March 5, 1993

I want to bring to your attention two issues of concern to the State of New Jersey regarding the jurisdiction over, and cleanup standards for, the Heritage Minerals site in Lakehurst, New Jersey.

SUBJECT: Heritage Minerals, Inc.

Subject: Heritage Minerals, Lakehurst, New Jersey

ATTACHMENT 1

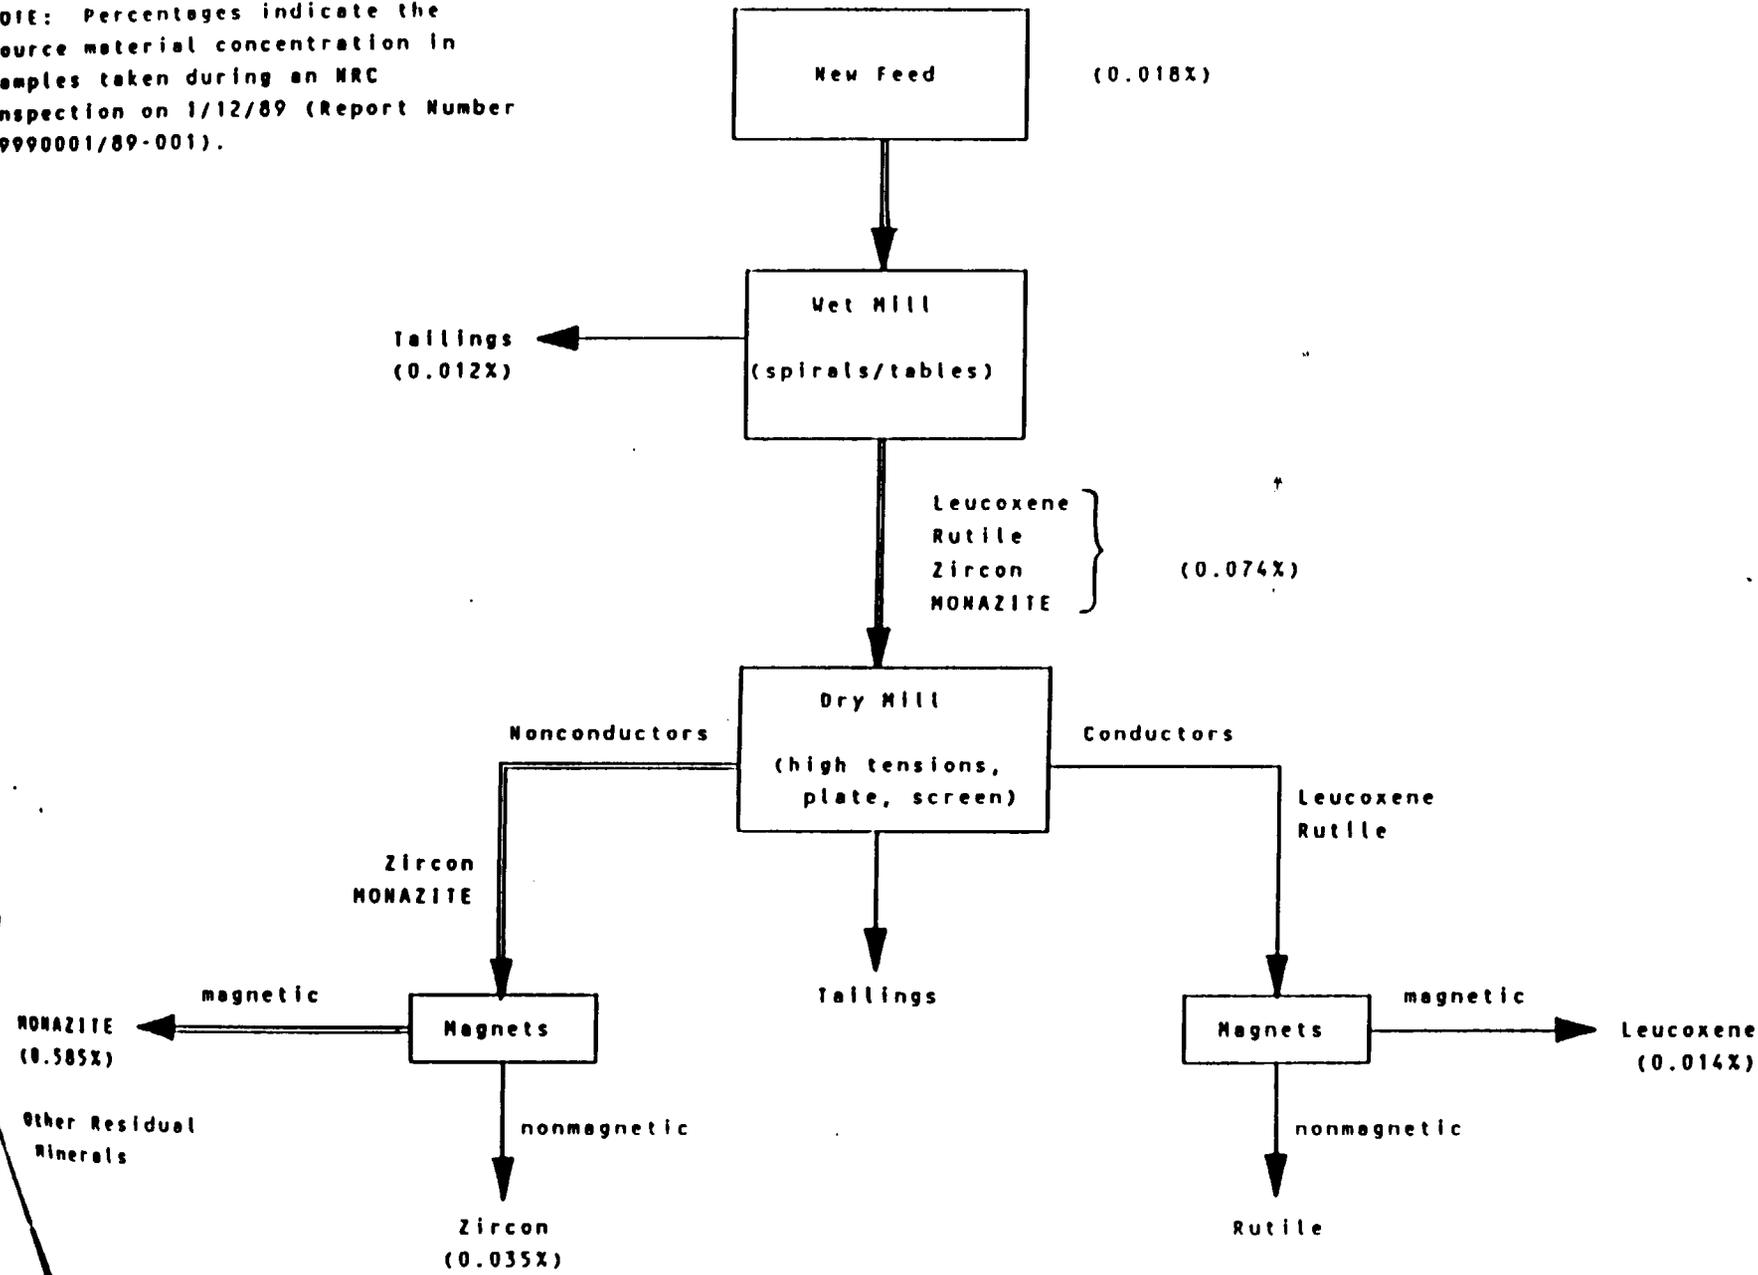
As you know, MRI, HMI Phase I and HMI Phase II operations employed the same physical mineral separation processes, differing only in the source of new feed and in the location and disposition of the monazite waste. Generally, new feed entered the

wet mill where zircon, leucoxene, rutile, and monazite were concentrated (see Attachment 1). In the dry mill, the conductors (leucoxene and rutile) were separated from the non-conductors (zircon and monazite). The rationale which you provided to us only addresses the process stream for conductors, which does not contain monazite. We address below the process stream for non-conductors in which monazite is separated from zircon.

During MRI and HMI Phase I operations (November 1986 - March 1990) at the point where zircon was magnetically separated from monazite in the dry mill, the monazite waste stream, at licensable source material concentration, was sent to a hopper where it was combined with tailings from the wet mill. These combined tailings were then pumped to the combined tailings pile. Perkins and Cole, attorneys retained by HMI, in their September 27, 1990 letter to you stated that "... monazite waste at source material concentrations was re-combined with other materials and placed in the area marked in blue on the site map [the combined tailings pile]..." HMI did not possess an NRC license for any portion of Phase I operations. As documented in NRC Inspection Report Number 99990001/89-001, HMI "possessed and used ... monazite waste in which the concentrations of source material were greater than 0.05% by weight without being authorized to do so by an NRC license..."
